Major Tool & Machine, Inc.
1458 East 19th Street
Indianapolis, IN 46218-4289

Part: SE141-116 / MODULAR COIL WINDING FORM TYPE

Drawing ID: SE141-116

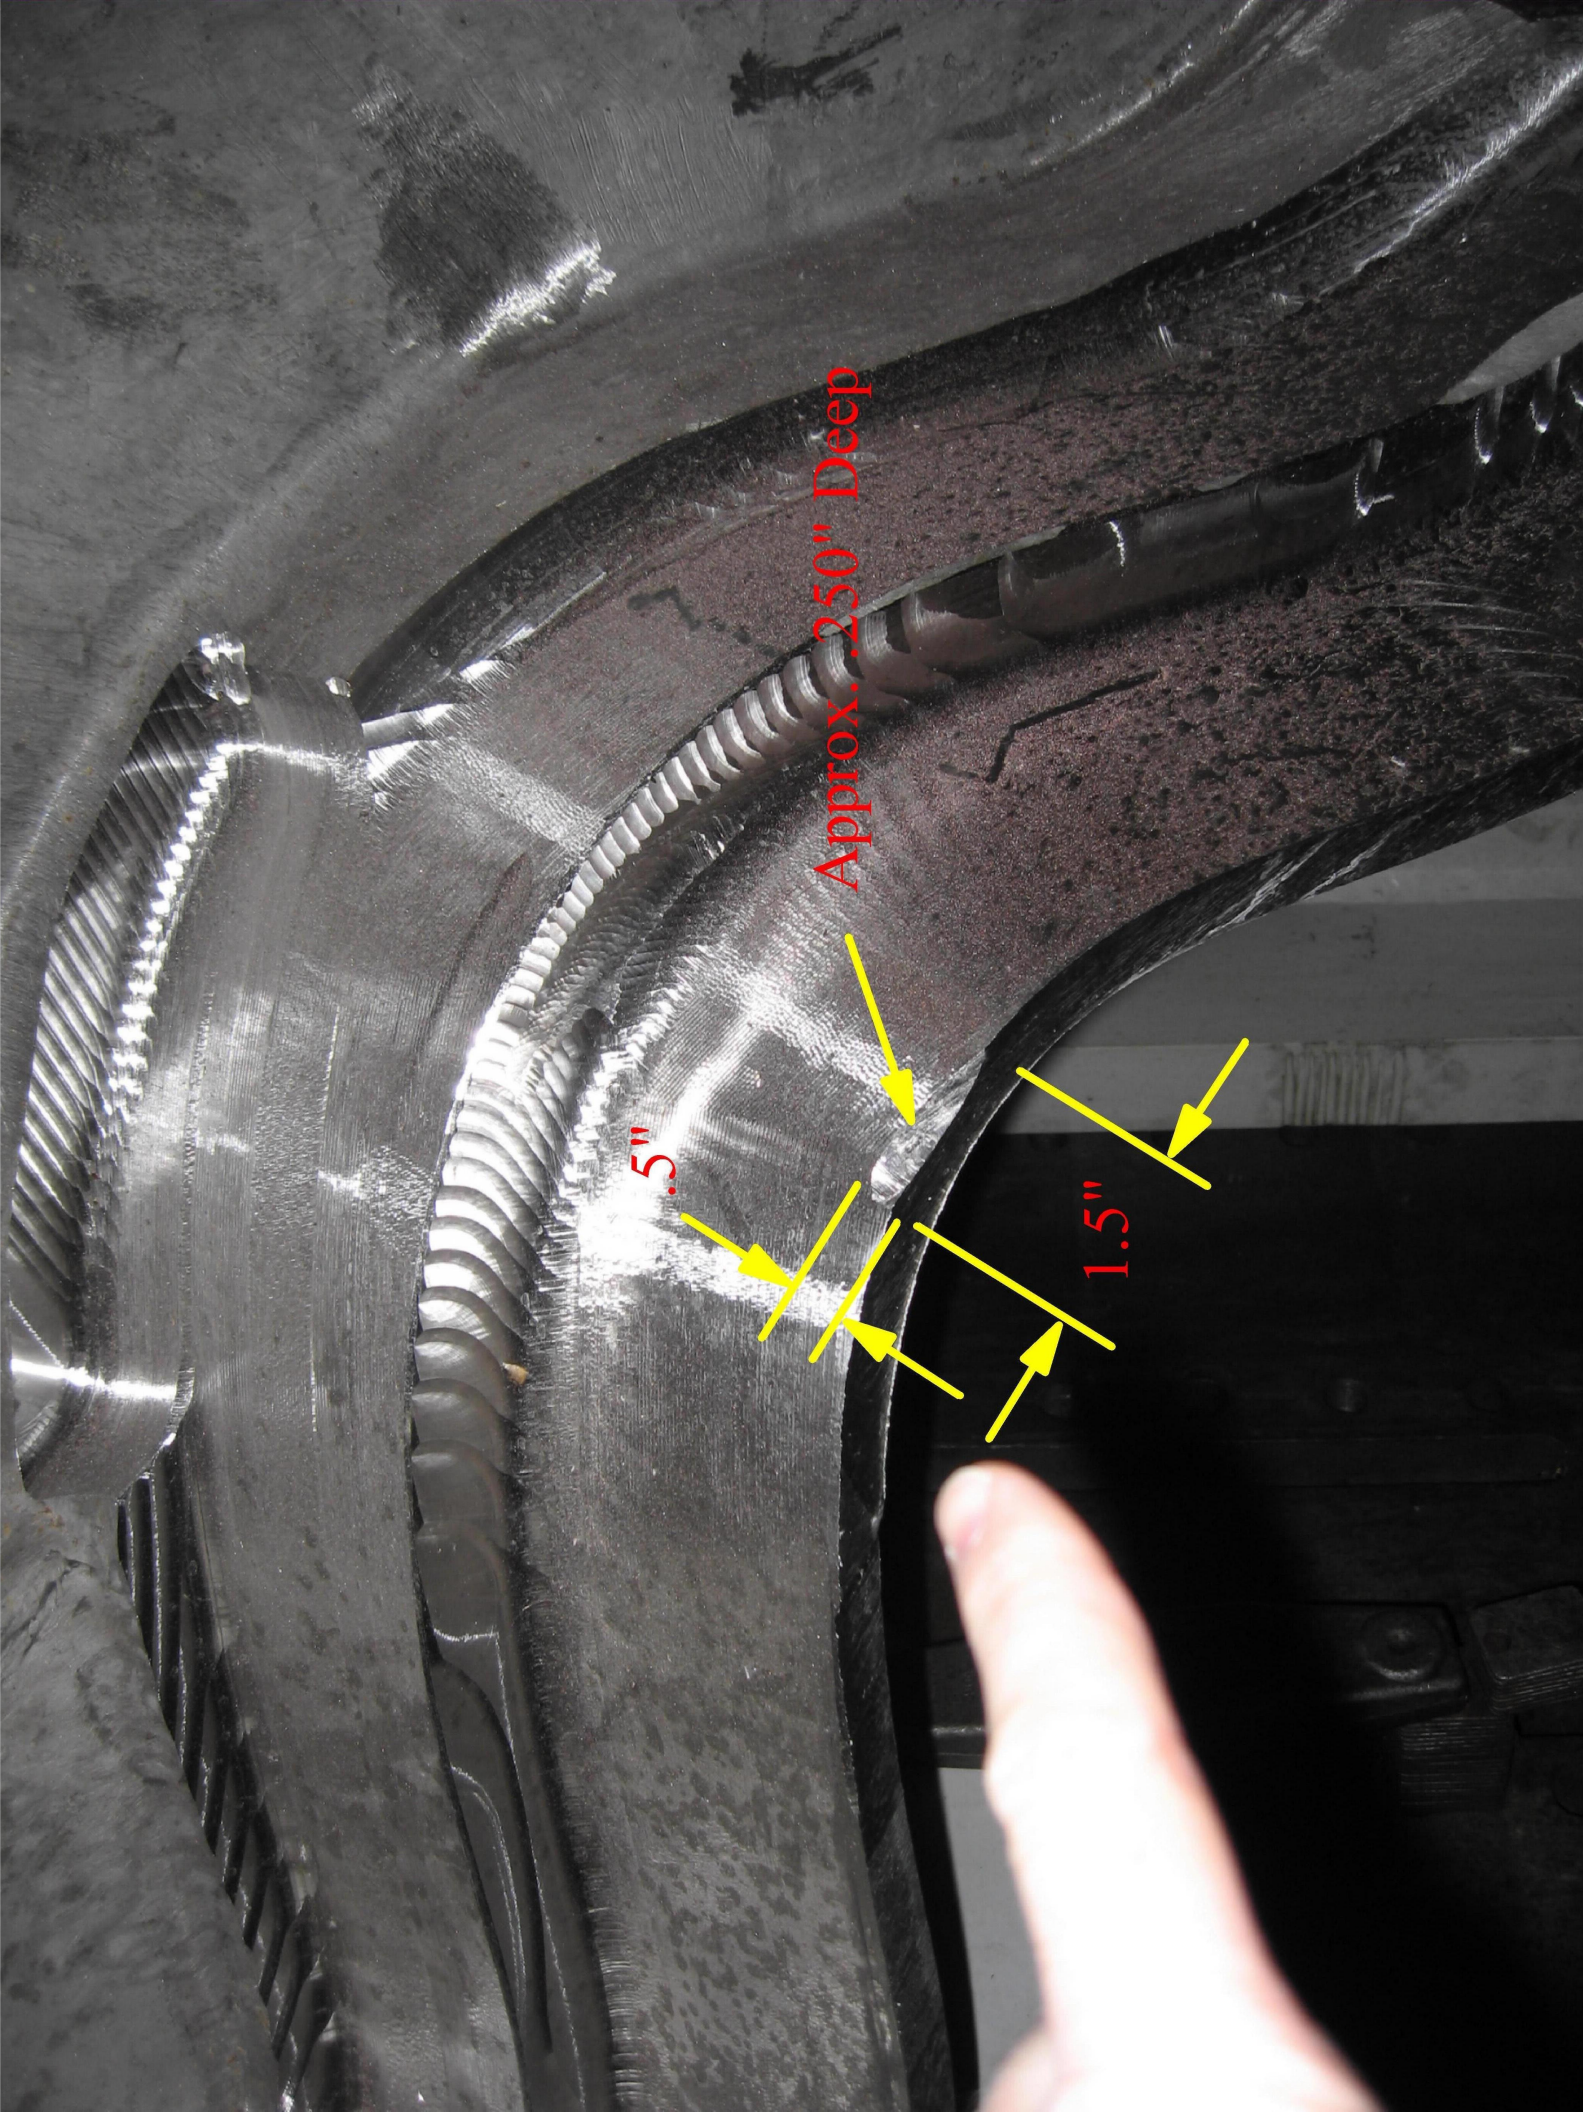
Problem: TOOL GOUGE APPROXIMATELY 1.5" LONG X .5" WIDE AND .250" DEEP ON THE CORNER OF THE T.
GOUGE IS LOCATED ON THE DATUM -D- SIDE (SEE PICTURES).

Resource: CAD/CAM – LARGE MILLING Equipment:
Description: THE TOOL-GOUGE OCCURRED AS A RESULT OF A PROGRAMMING ERROR. PROGRAMS HAD BEEN MODIFIED TO HELP REDUCE MACHINING CYCLE. THE NEW PROGRAM WAS VERIFIED USING VERICUT PRIOR TO RELEASING TO THE MACHINE. THE PROGRAMMER AGAIN VERIFIED THE PROGRAM AFTER THE GOUGE OCCURRED AND DISCOVERED THAT THE ERROR HAD BEEN DETECTED BY VERICUT. THE PROGRAMMER WAS NOT CORRECTLY INTERPRETING THE RESULTS FROM THE VERIFICATION PROCESS.

RECOMMEND WELD REPAIR OF DEFECTIVE AREA PRIOR TO FINISH MACHINING.
ALSO RECOMMEND REPAIR TO BE INSPECTED USING PT AND MAG PERMEABILITY CHECK WITH
WAIVER OF THE X-RAY REQUIREMENT.

PPPL concurs with Major Tools recommended disposition.

Description: THE PROGRAMMER HAS BEEN GIVEN ADDITIONAL TRAINING ON THE USE OF VERICUT AND FULLY UNDERSTANDS HOW THE ERROR WAS MISSED.
